## **Thorpe on the Hill Parish Council (PC) IP Ref: [REDACTED]**

### **Mitigation of the proposed FGE Solar Farm on the “Stepping Out” (SO) routes in Thorpe on the Hill**

# Current scheme based upon an assembly of images to provide an overview

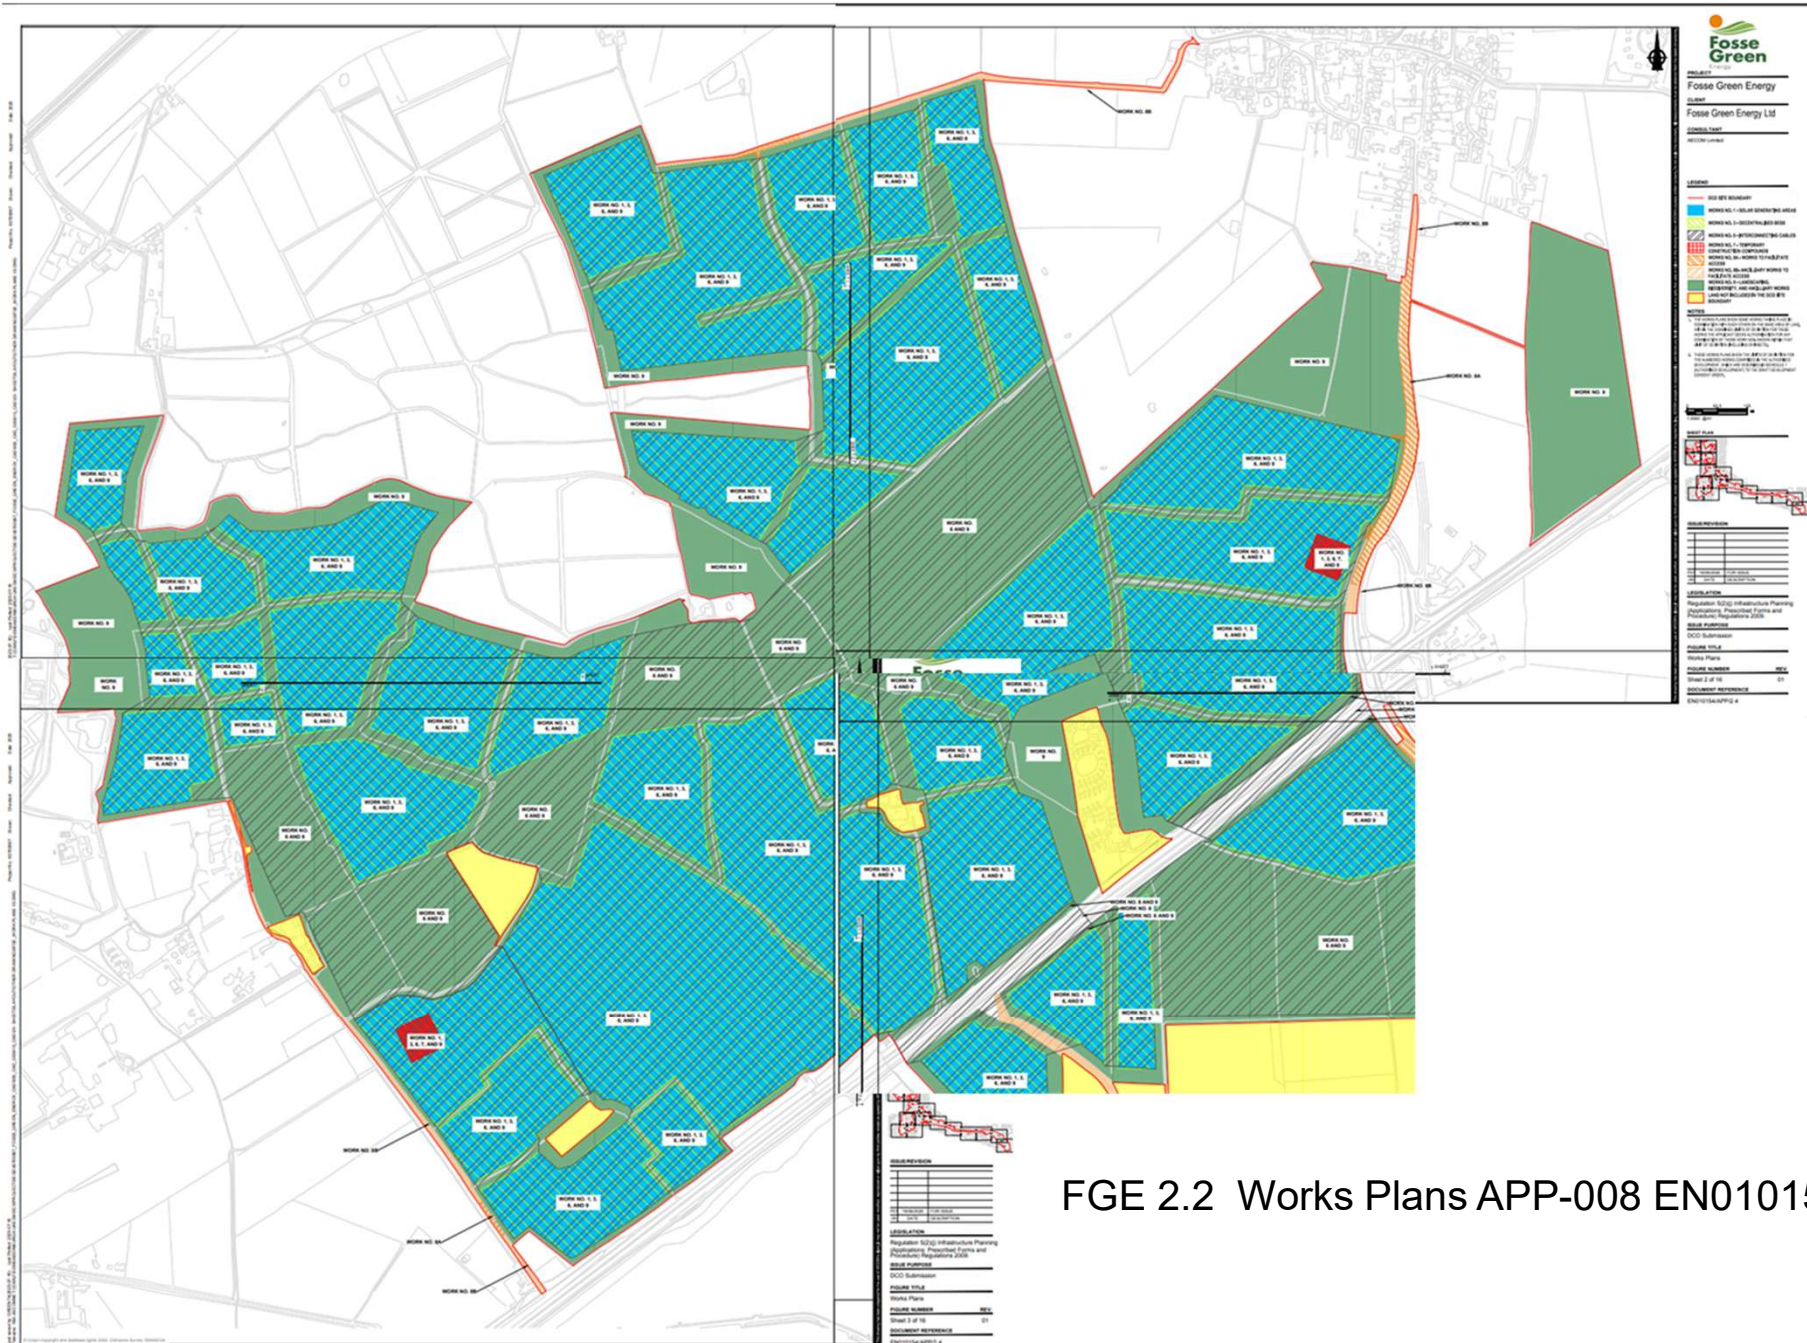
The PC does not believe that adequate consideration has been given to properly mitigating the potential effects of the proposed scheme on these routes. The following pages of this document contains reminders of the routes themselves which have been copied from the promotional leaflets. The diagram on page 4 is taken directly from the applicant’s documents FGE 2.2 Works Plans APP-008 EN010154 and shows the layout of solar arrays in the area surrounding the SO routes.

The final layout on page 5 shows what the PC considers to be a much-improved mitigation scheme. This is based upon the following design principles:

- Avoid any corridors where the SO routes would pass through solar arrays on both sides of the path creating tunnel effects. As a compromise solar arrays on one side of paths, where views are less important, are included
- Try to retain key views to Tunman Wood from the village and from Tunman Wood back to the village
- Try to retain key views identified in Thorpe on the Hill’s Neighbourhood plan
- Maintain, so far as is possible, open views which are characteristic of the locality rather than restrictive hedgerows which block key views
- Avoid changes which impact the integrity of the applicant’s proposal by requiring different access points or new parcels of land

Thorpe PC cannot claim professional planning expertise however, these simple revisions which are shown on page 5 appear very practical and do not require wholesale design changes to the applicant’s proposals. They would result in a reduction in area of solar arrays in the affected areas close to the SO routes but it might possible to recoup these elsewhere. If implemented, the PC believes they would enable many of the key features and benefits of the SO routes to be retained.

# Revised scheme with localised mitigation
